# TOWN OF CORTLANDT PLANNING BOARD

**MEETING AGENDA.....PLANNING BOARD**  
**TOWN OF CORTLANDT**  
**6:30 TUESDAY EVENING\***  
**OCTOBER 1, 2024**

**PB 2024-1** a. Public Hearing: Application of KPB Properties LLC for Site Development Plan approval and a referral from the Town Board of a Petition for a Zoning Text Amendment for a proposed 4-story, 75,000 sq. ft. self-storage facility located at 3 Locust Avenue. Drawings latest revised September 24, 2024.

PROJECT NAME: **PROPOSED SELF-STORAGE FACILITY**  
3 LOCUST AVENUE  
CORTLANDT MANOR, NY 10567  
COUNTY OF WESTCHESTER  
SECT.: 34.5, BLOCK: 2, LOT: 6

**PROPOSED BUILDING HEIGHT CALCULATION PLAN**  
1" = 60'

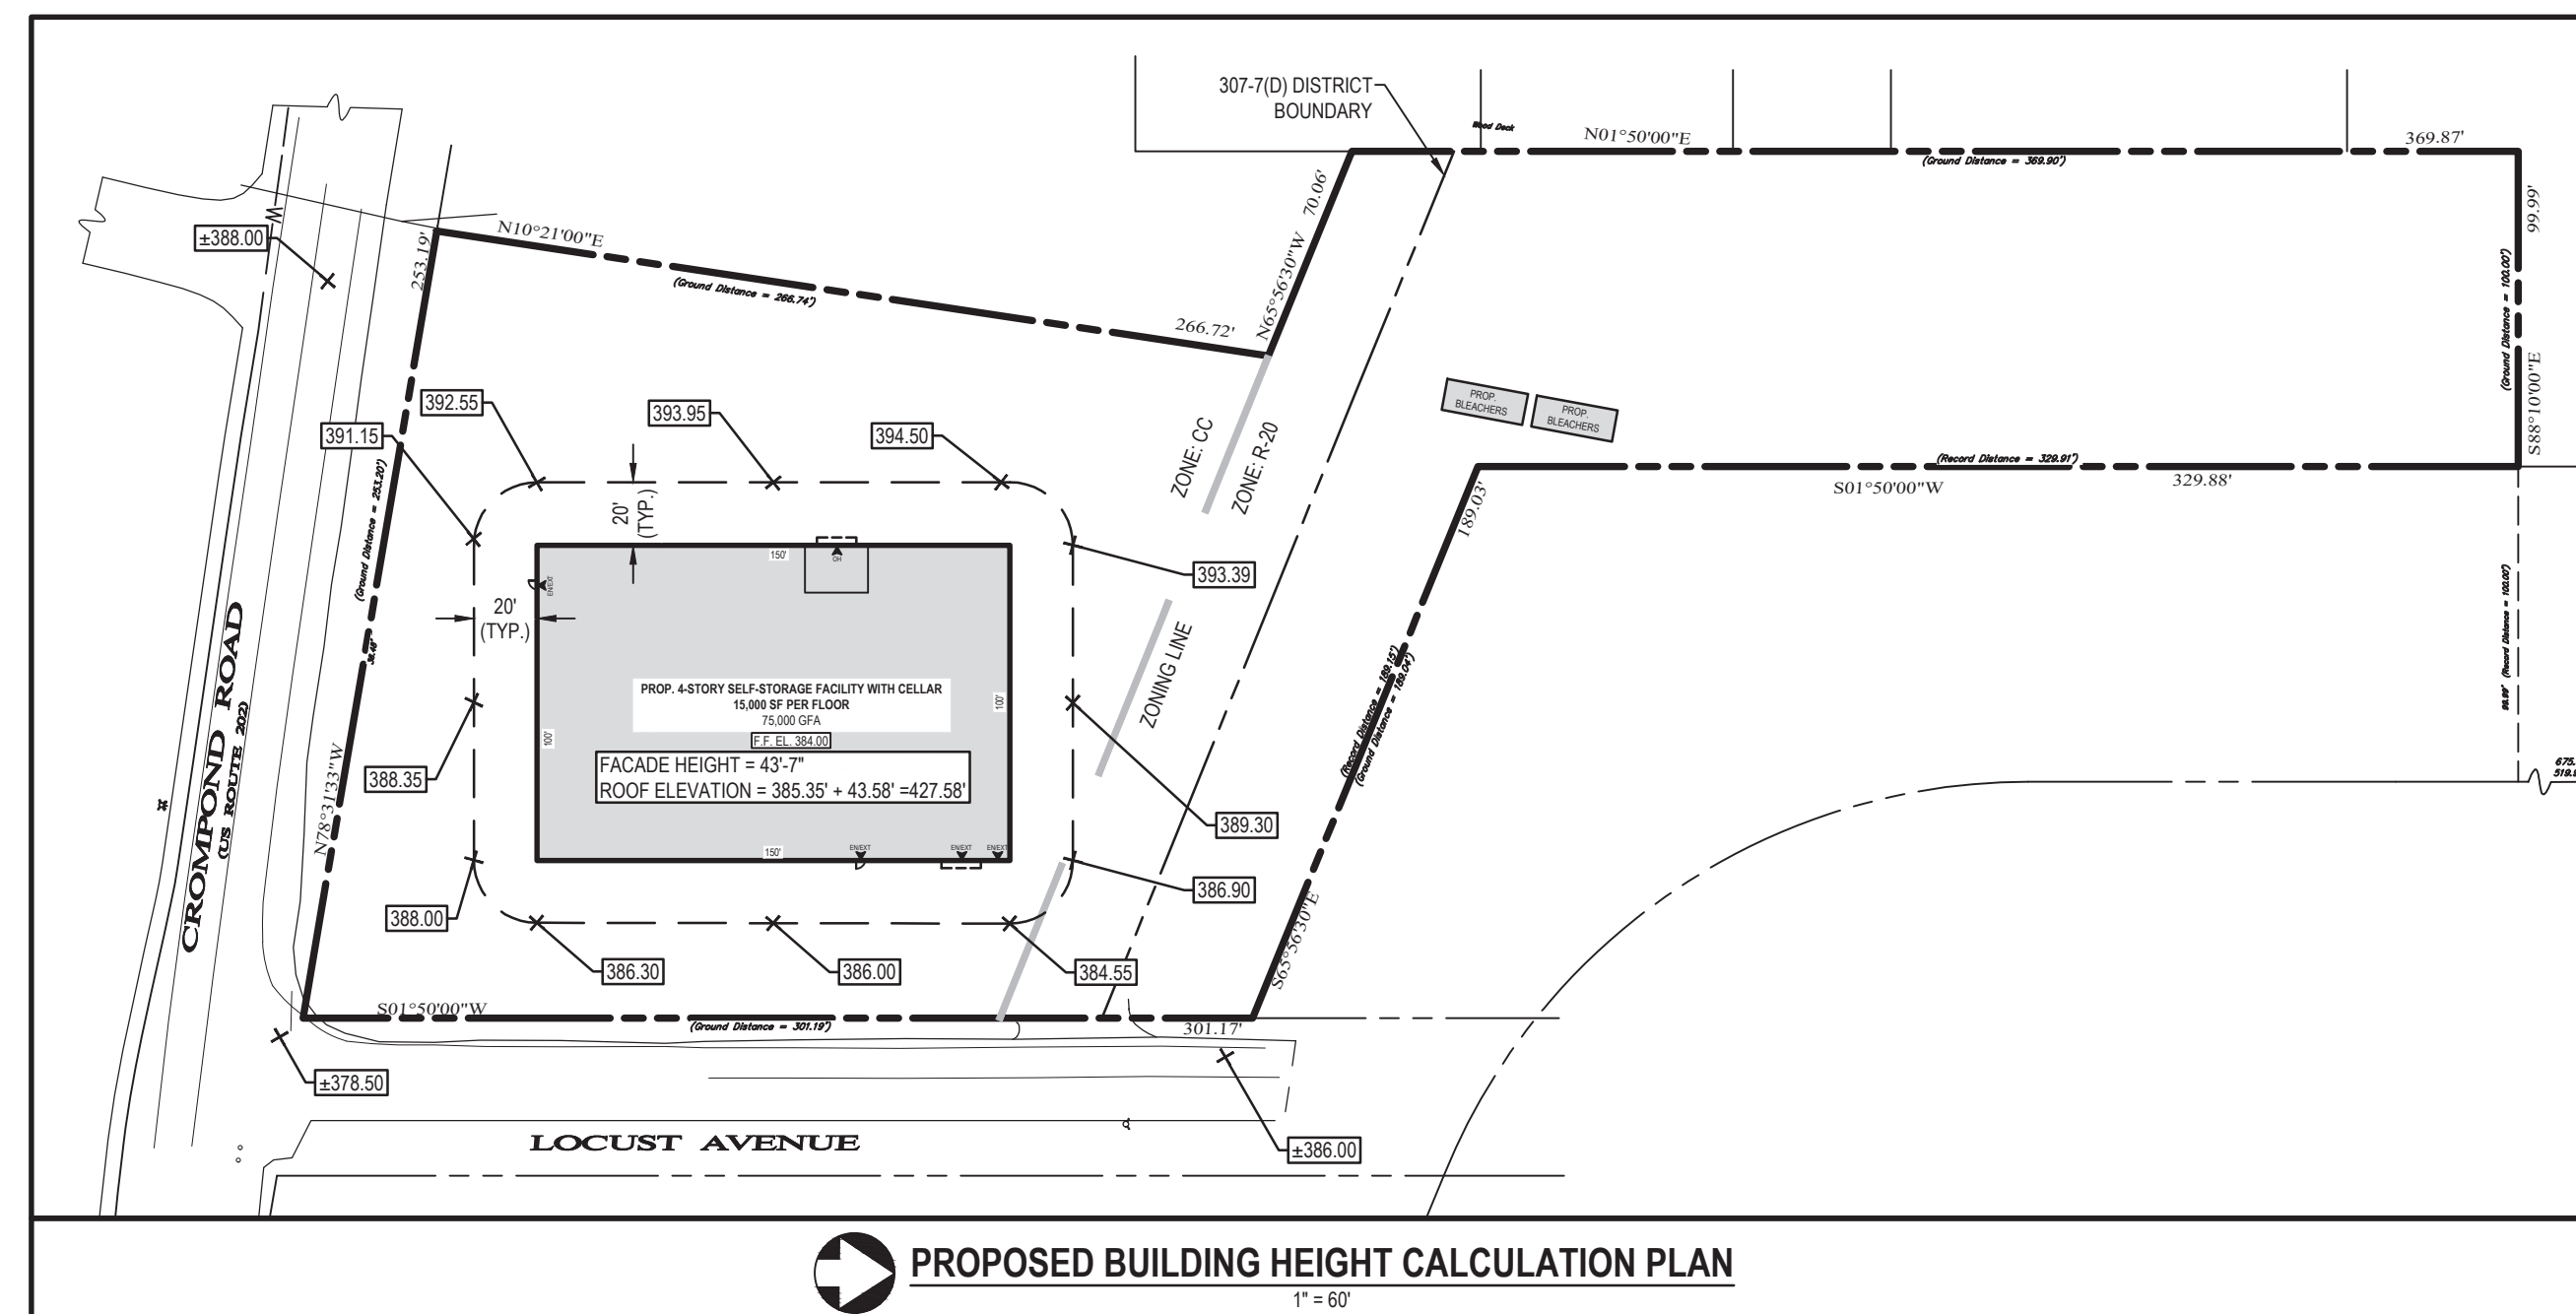
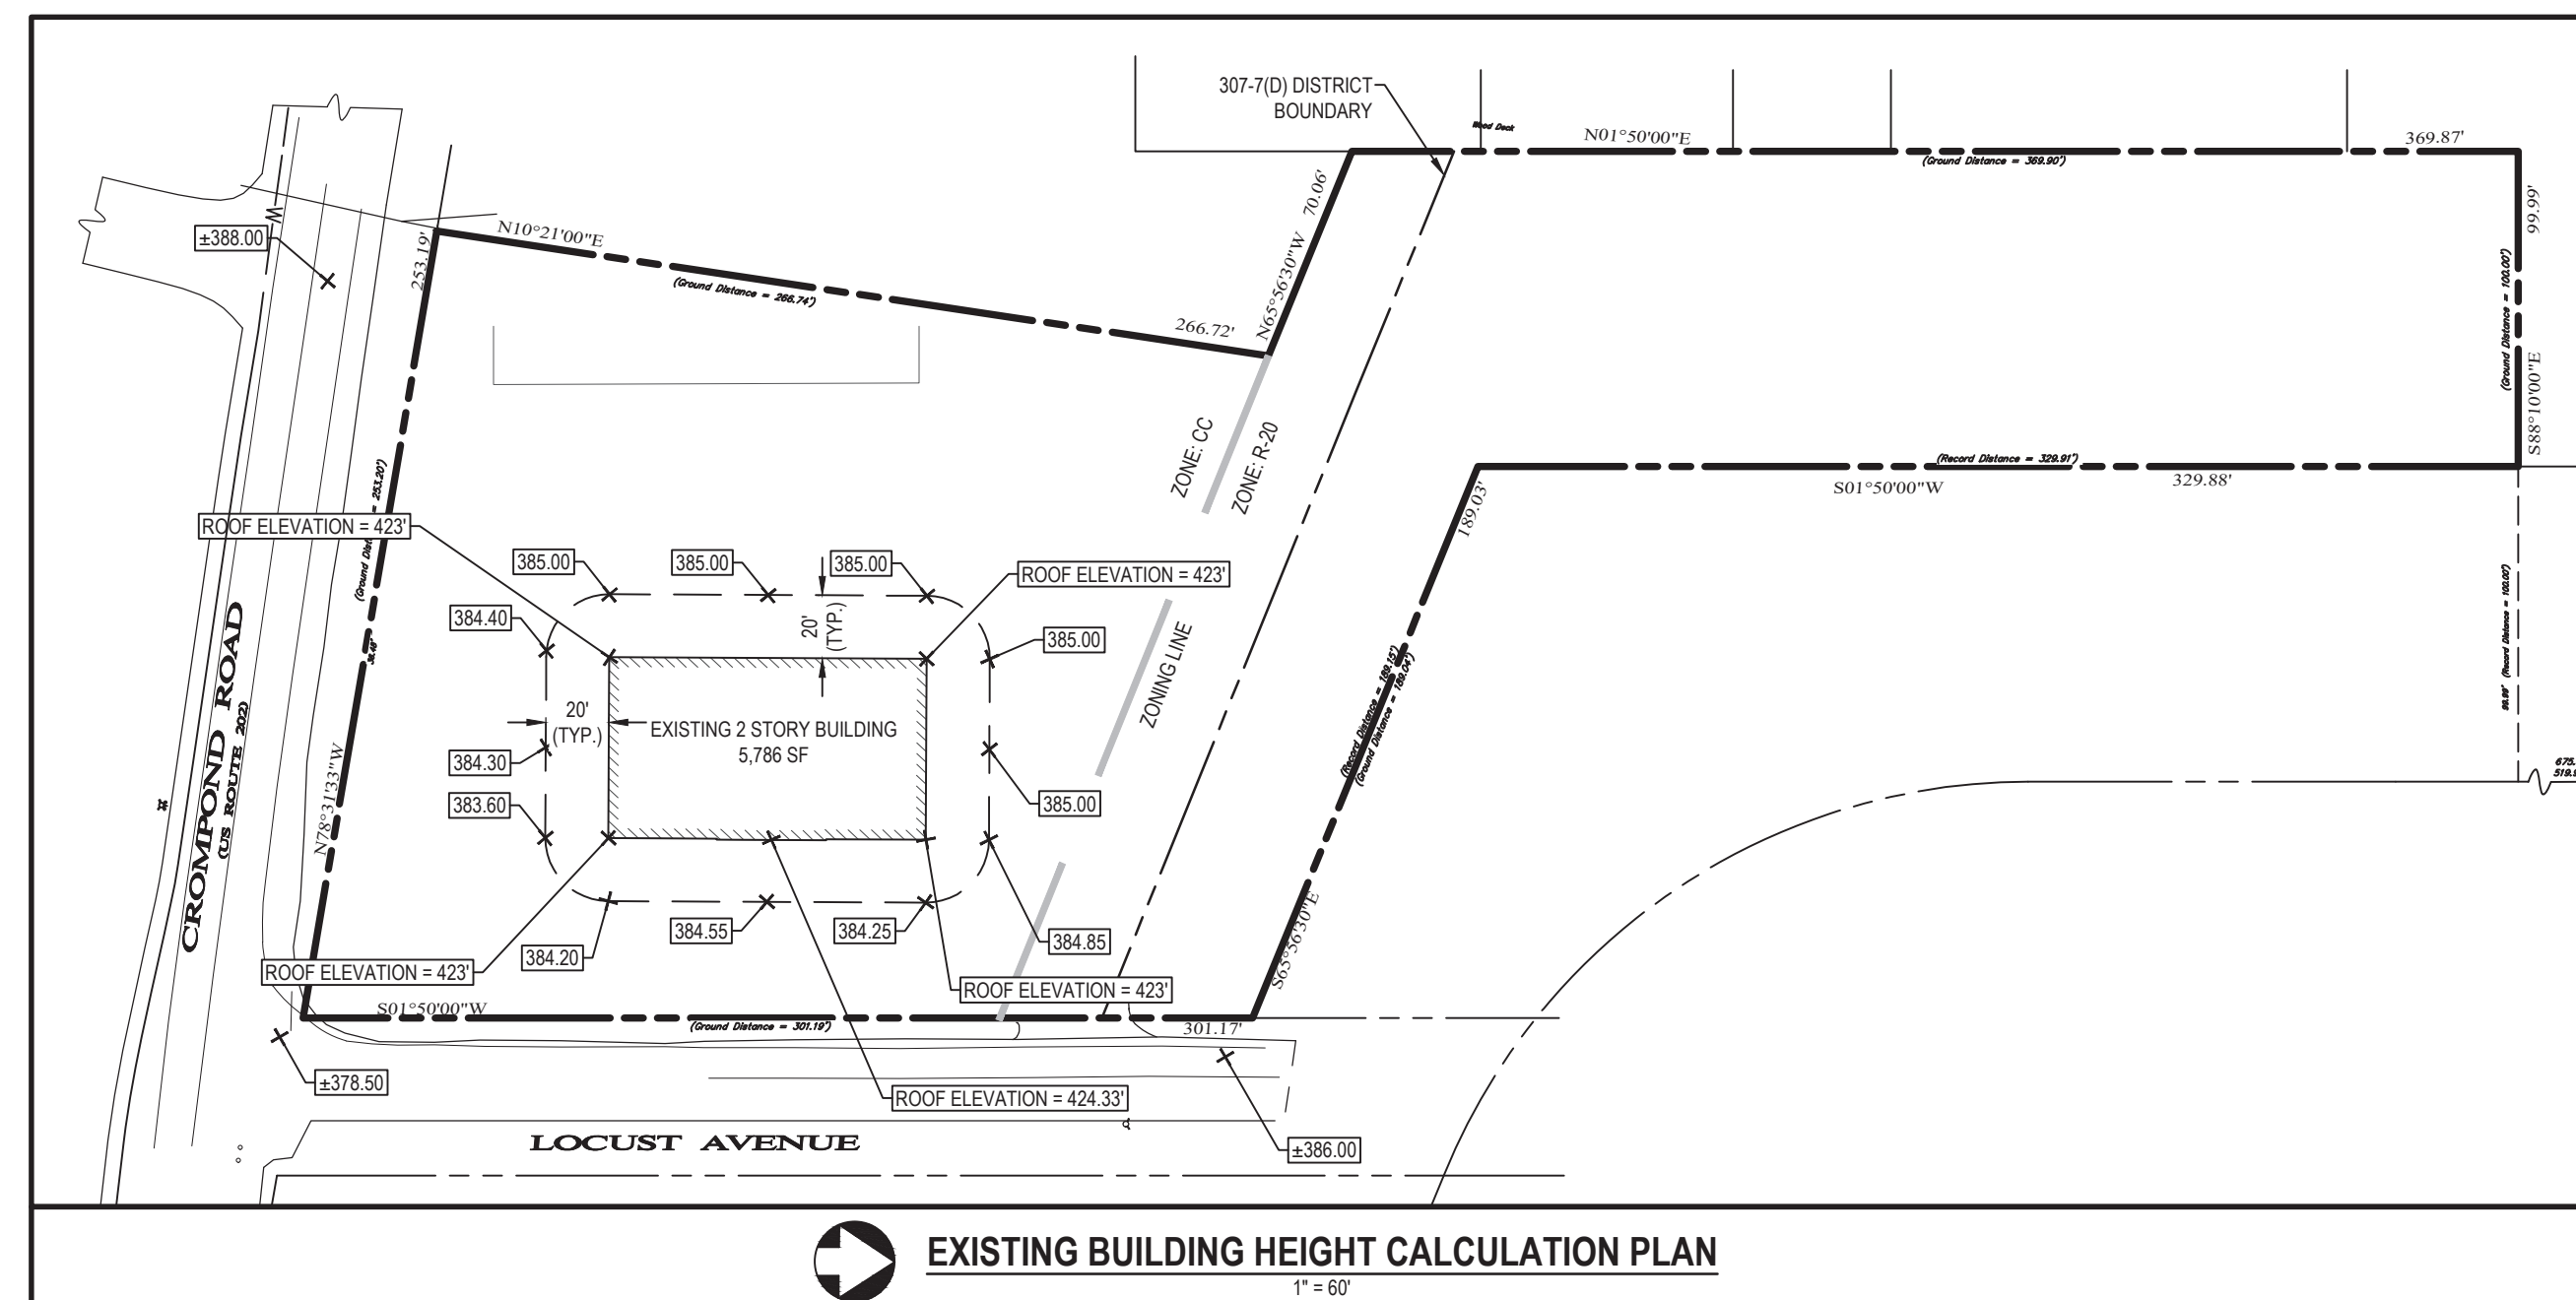
8. Sheet C-1A: Provide delineation of saw cut line within Locust Avenue for existing water service lateral.

9. Sheet C-1A: Please provide the following notes on the plans:
- Contractor shall Locate and remove all components of the existing subsurface sewage disposal system servicing the existing building.
  - Septic tanks, leaching fields, and other similar facilities associated with the existing building shall be pumped free of septage or sewage, removed and the resulting hole shall be backfilled in lifts of compacted suitable fill material.
  - Tanks shall be pumped by a NYSDEC Certified Septic Waste Transporter and removed from the site in accordance with NYSDEC transport and disposal requirements.
  - The abandonment and/or decommissioning of the existing subsurface sewage disposal system must be in accordance with the procedures approved by the Westchester County Department of Health and certified by a licensed NYS Professional Engineer.

**Response: Sheet C-1A is for purposes of calculating the existing and proposed building heights; adding the saw cut line for the proposed water services would only clutter the drawing and as such we respectfully request that the comment be omitted.**

**Response: The requested notes have been added to Sheet C-1A.**

DRAWING No: **C-2**

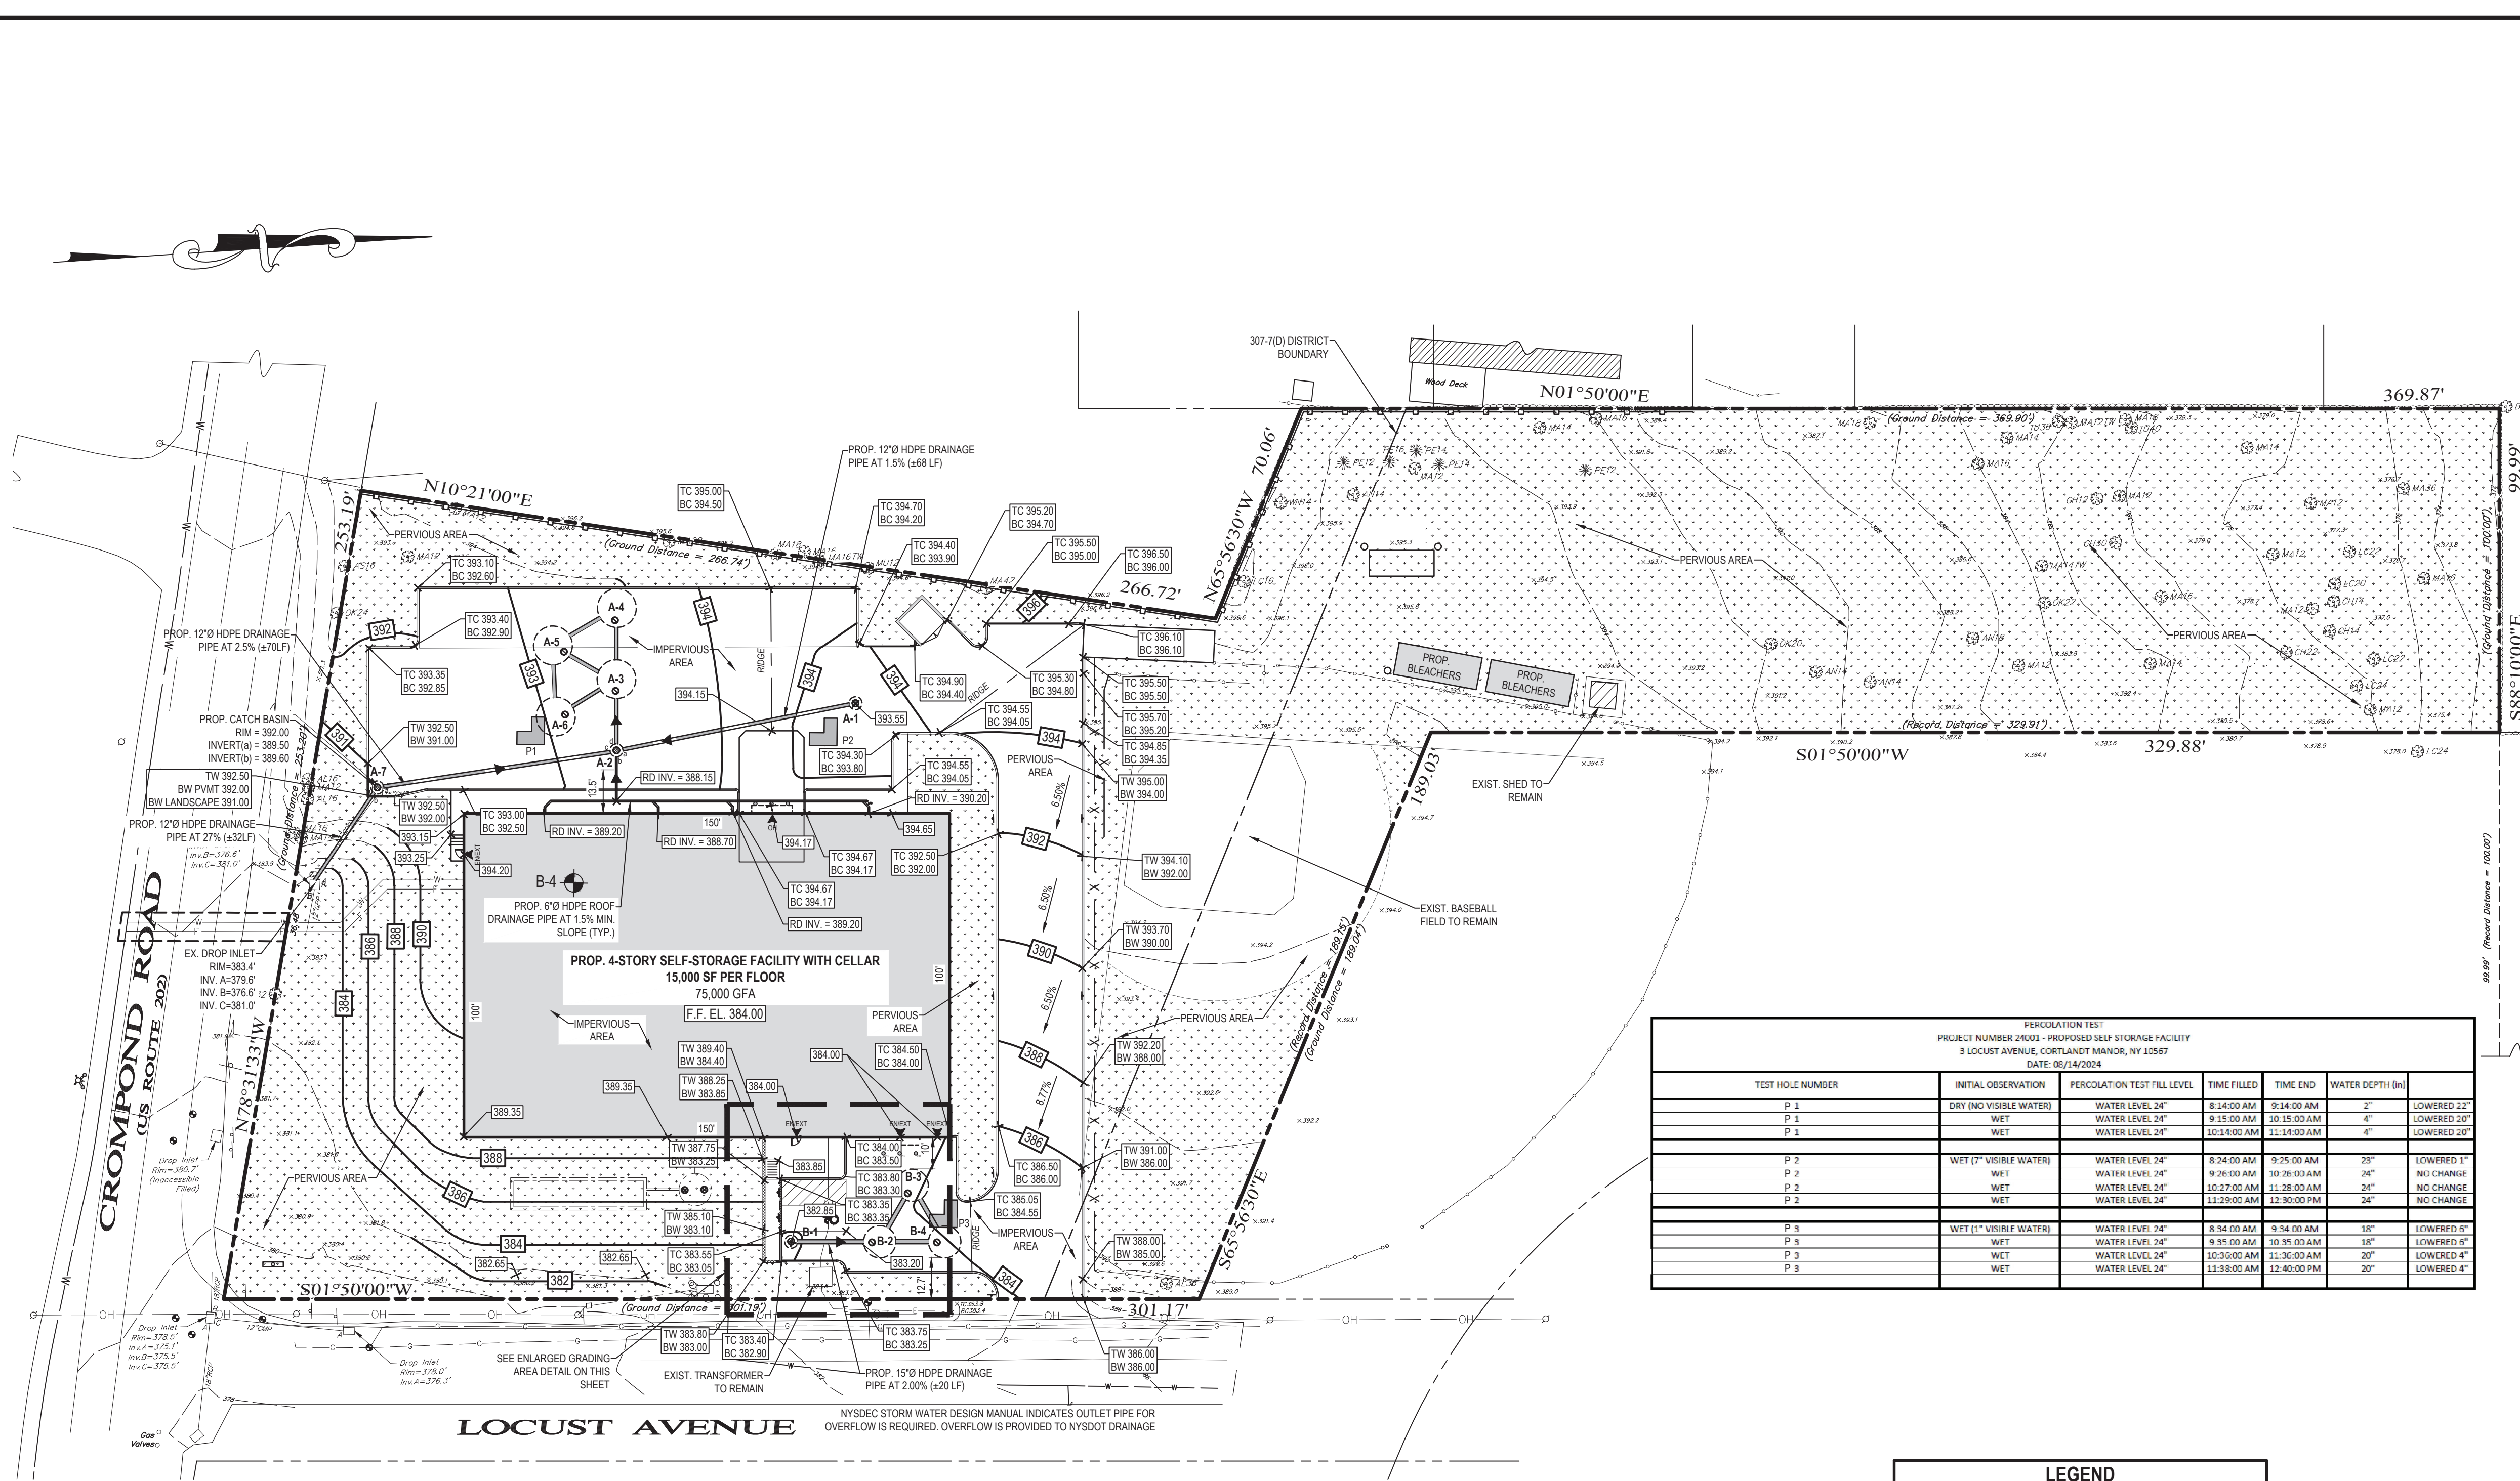
10. Sheet C-2 (site removals) notes that the existing retaining wall along the north edge of the entrance driveway will be removed, but sheet C-3 (grading/drainage) indicates a retaining wall will remain, per the topo notes along the drive that reference elevations at the top and bottom of the wall. The applicant shall confirm whether the retaining wall will remain, and correct the submitted information accordingly.
